MFN 08-430

Subject: **Response to Portion of NRC Request for Additional Information Letter No. 124 Related to ESBWR Design Certification Application – Passive Containment Cooling System – RAI Number 3.8-117**

1. Response to Portion of NRC Request for Additional Information Letter No. 124 Related to ESBWR Design Certification Application – Passive Containment Cooling System (PCCS) -- RAI Number 3.8-117

RAI Number 3.8-117

Figure 3.8-7. RCCV Top Slab Penetration and PCCS Passages

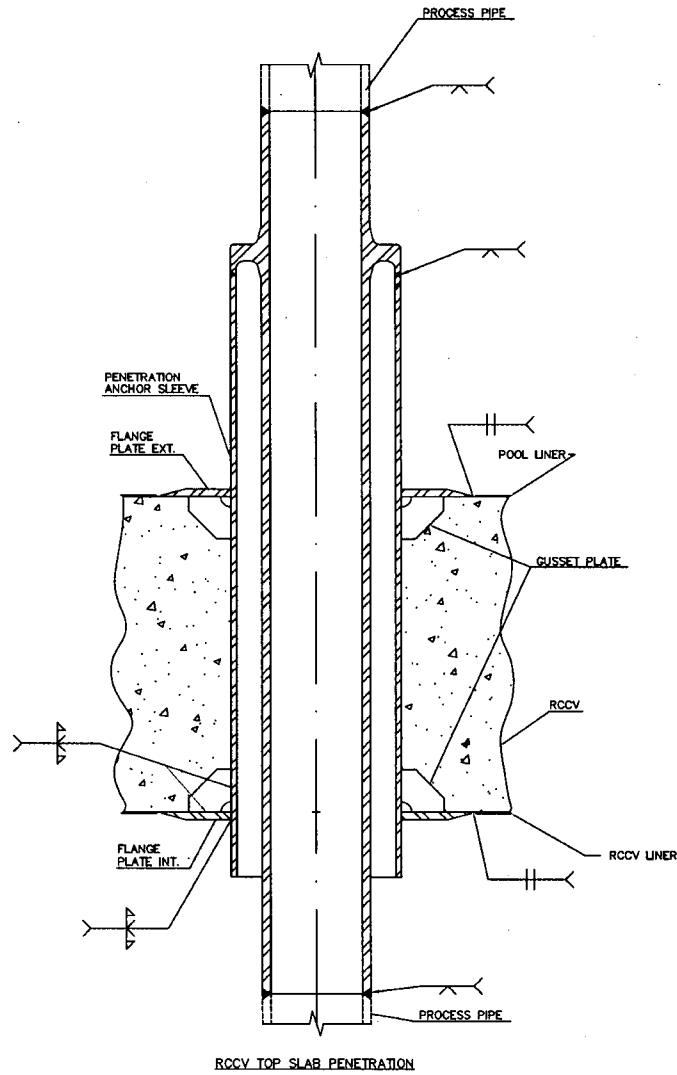
b. The PCCS condensers are designated as part of the containment pressure boundary. This appears to be a unique application of condensers. In order to develop reasonable assurance that the containment has been adequately designed, the staff requests the applicant to provide a comprehensive description of the condenser and connecting piping. The description should include details and figures showing the individual parts of the condenser and how they are connected; dimensions; materials; the piping and pipe supports between the containment top slab and condenser; and the supporting elements from the condenser to the top slab and lateral supports to the pool walls.

- b. The PCCS Condensers are described in DCD Tier 2 Subsection 6.2.2. Two figures showing the PCCS Condenser and supports will be added in DCD Tier 2 Appendix 3G for details of the overall configuration including individual components and their supports, key dimensions and associated materials. DCD Tier 2 Figure 3.8-7 shows typical detail for the PCCS passages through the RCCV Top Slab.

containing the feed line, return line and drain lines ~~penetrate~~ pass through the RCCV Top Slab. The lines connected to the condenser and the sleeves are part of the containment boundary. Figure 3.8-7 shows the typical configuration for these passages through the RCCV Top Slab and Table 3.8-17 lists each of these passages and their function.

Figure 3G.1-71b. PCCS Condenser and Supports Details

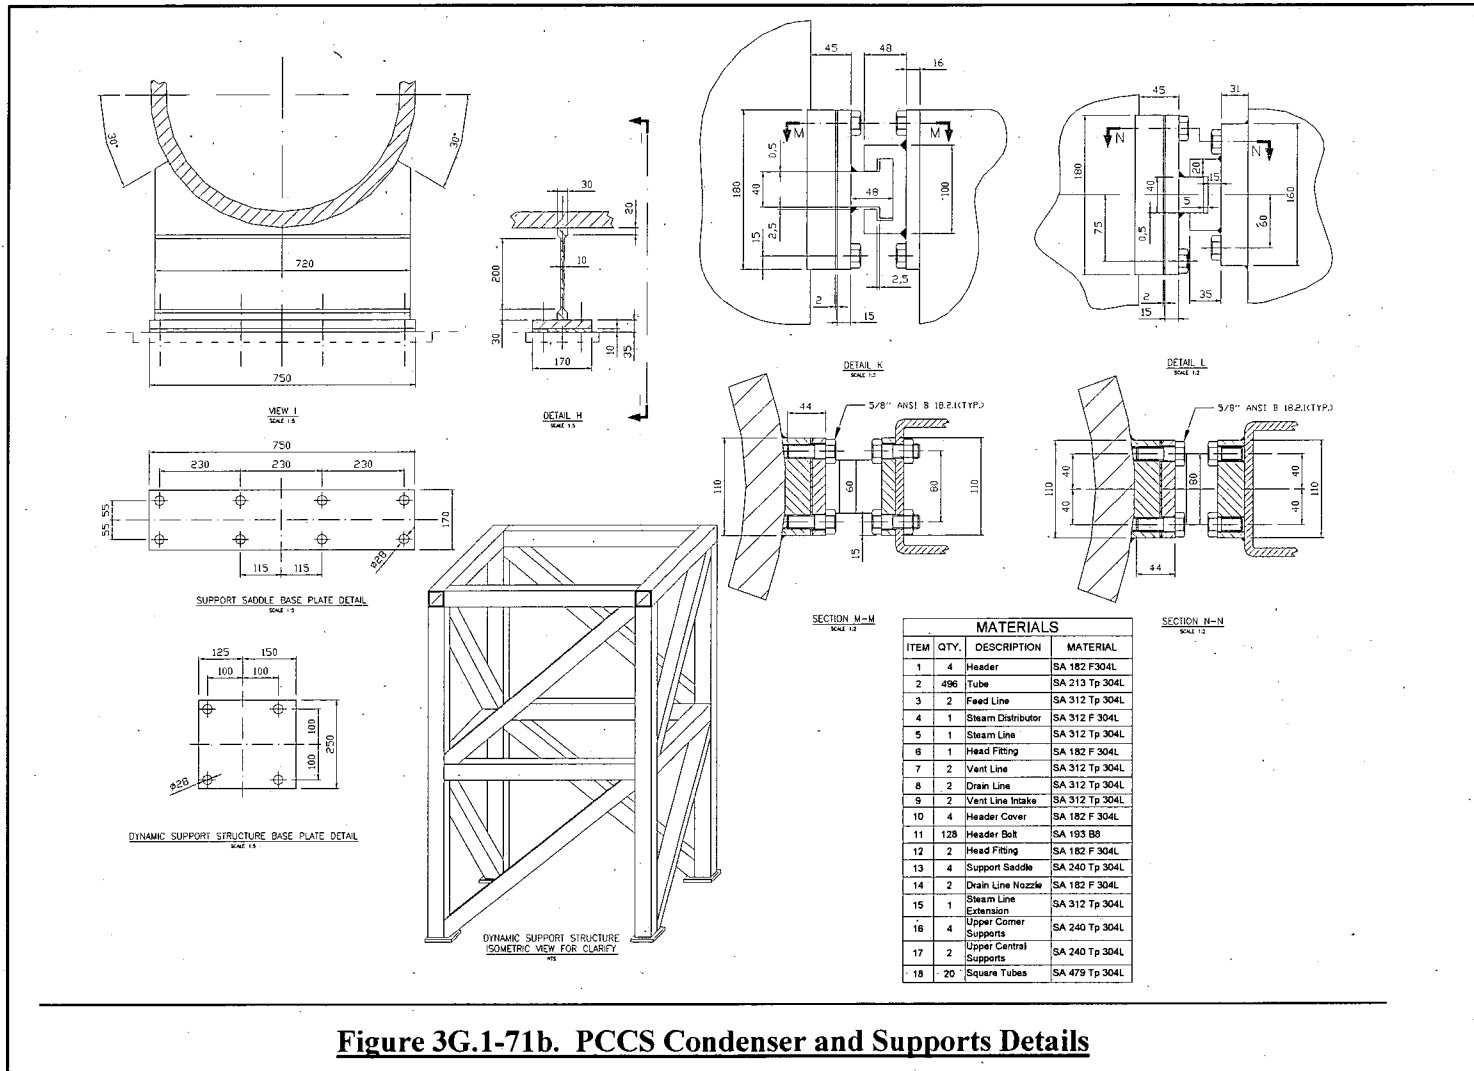
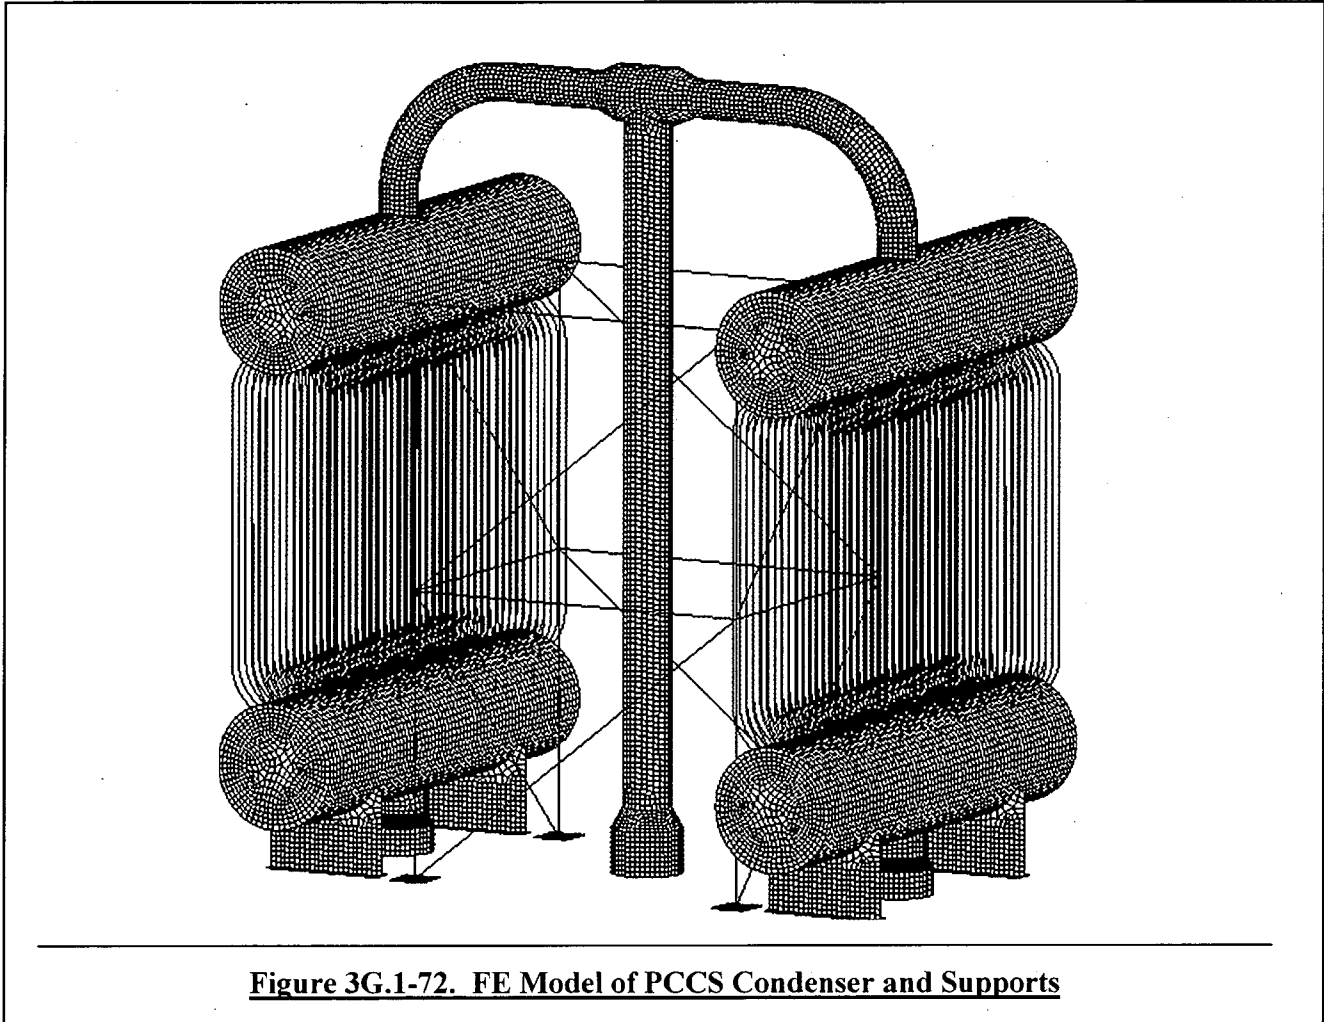
c. Since the PCCS condensers and piping are part of the containment pressure boundary, include in the DCD a description of the analysis and design evaluation (including results) comparable to the information provided for other steel components of containment.

- c. A finite-element analysis model supplemented with hand calculation is used to determine the stresses in the different components of the PCCS Condenser and supports. A description of the analysis and main results for the PCCS Condenser and supports is included in DCD Tier 2 Appendix 3G, Subsections 3G.1.5.4, 3G.1.5.4.1, 3G.1.5.4.1.5, Figures 3G.2-71a, 3G.1-71b, 3G.1-72, and Table 3G.1-60.

The PCCS condenser is anchored to the RCCV Top Slab and is laterally supported by ~~the IC/PCC pool walls~~ a 3D steel frame structure that transmits the horizontal dynamic forces to the RCCV Top Slab. Figures 3G.1-71a and 3G.1-71b show the PCCS condenser and supports.

Figures 3G.1-71a and 3G.1-71b show the design details. A finite-element analysis model supplemented with hand calculation is used to determine the stresses in the different components of the PCCS condenser and supports. The finite-element analysis is performed using ANSYS computer code. The 3D finite-element model presented in Figure 3G.1-72 is used. The 3D steel frame structure and the vertical tubes are modeled by beam-type elements. The rest of PCCS condenser components are modeled by shell-type elements. Static and dynamic analyses are performed to evaluate the different loads. The dynamic load cases are analyzed by the response spectrum method. The stress evaluation is performed for loads and load combinations in accordance with Table 3.8-4 and associated acceptance criteria for pressure retaining components of the condenser. The condenser supports are designed to the same loads and load
